**OS-PCN-2019-004-A**

**Introduction of backend production  
location Wuxi for SIDELED, TOPLED,  
Power TOPLED and PointLED products**

**Customer information package**

OS QM CQM | 02.08.2019

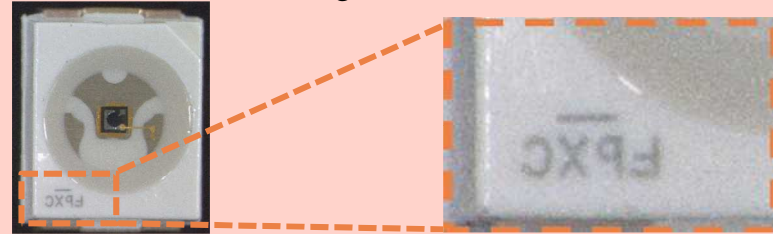
Introduction of backend production location Wuxi for SIDELED, TOPLED, Power TOPLED and PointLED products to secure continuous supply and merge similar production technologies (Portfolio competitiveness program)

For better traceability, laser marking on device will be rotated by 180° for devices assembled at location Wuxi.
